REGIONAL REVIEW FINDING

ARC REVIEW CODE: R1709131

Name of Proposal: Duncan Road Waste Transfer Station (DRI 2706)

DUNCAN ROAD PROJECT

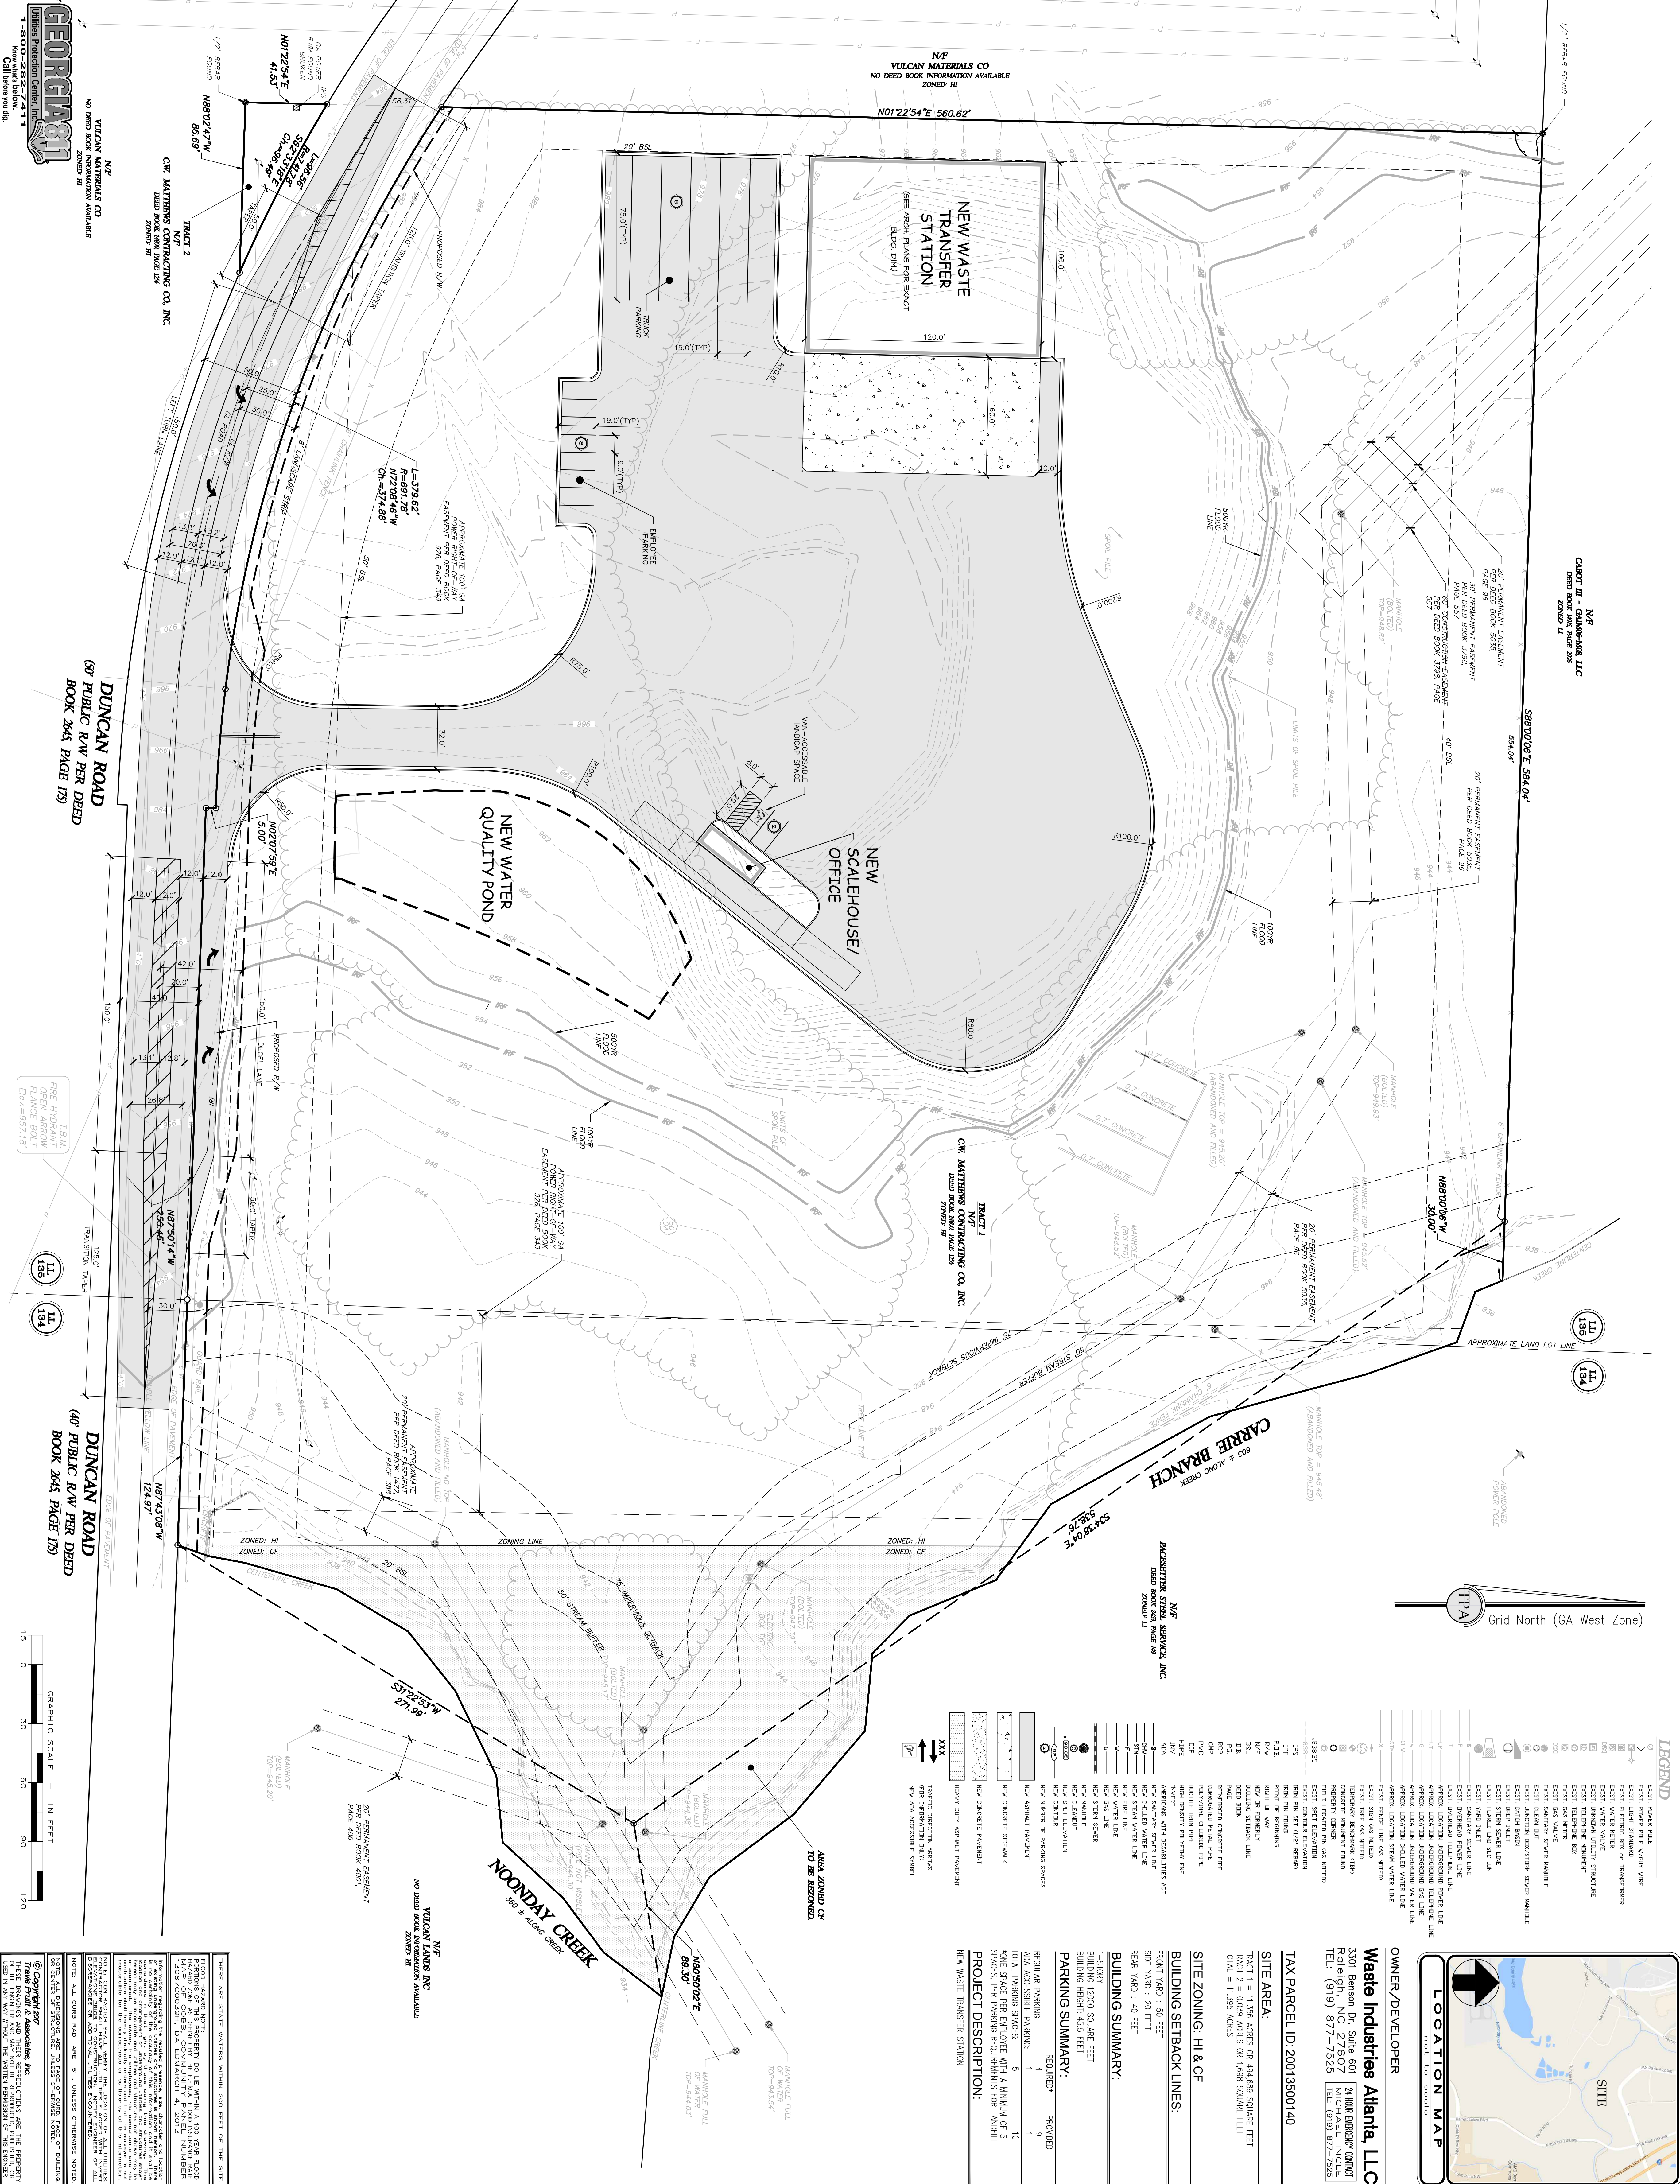
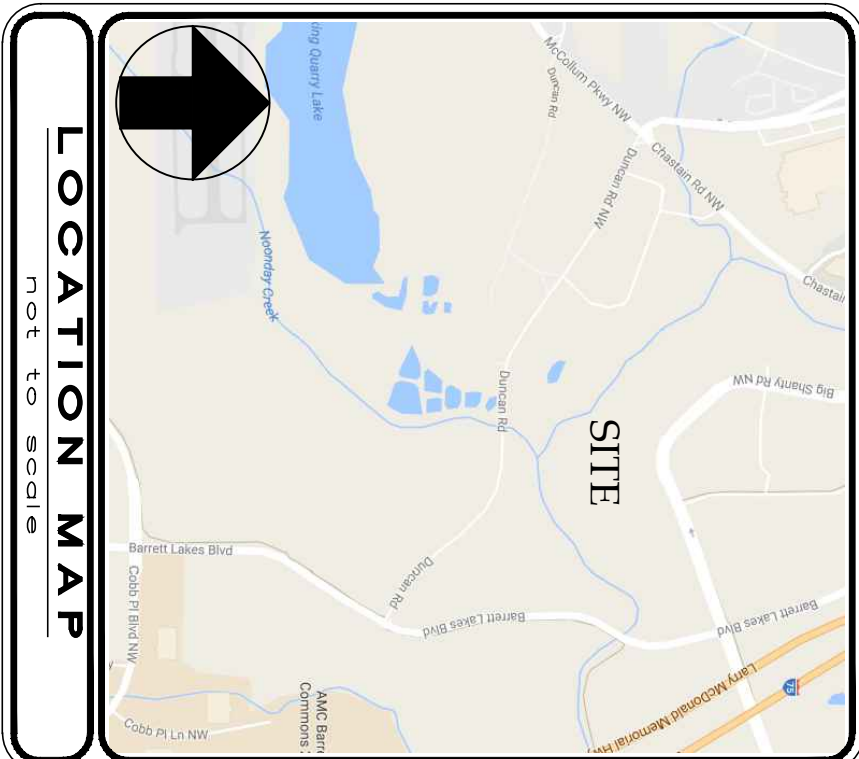
Both the USGS coverage for the project area and the site plan show Noonday Creek, a blue-line stream flowing to Allatoona Lake, as well as Carrie Branch, which is a blue line tributary to Noonday Creek, along the northeastern and eastern boundaries of the project property. The site plan shows a 50-foot undisturbed buffer and 75-foot impervious setback along both streams. However, these buffers are not identified and the State 25-foot sediment and erosion buffer is not shown. As Cobb stream buffers vary by stream, the required County buffer should be confirmed and properly identified on the plans. Any proposed intrusions into the County buffers may require a variance from the County. Any intrusions into the State sediment and erosion buffer will also require variances.
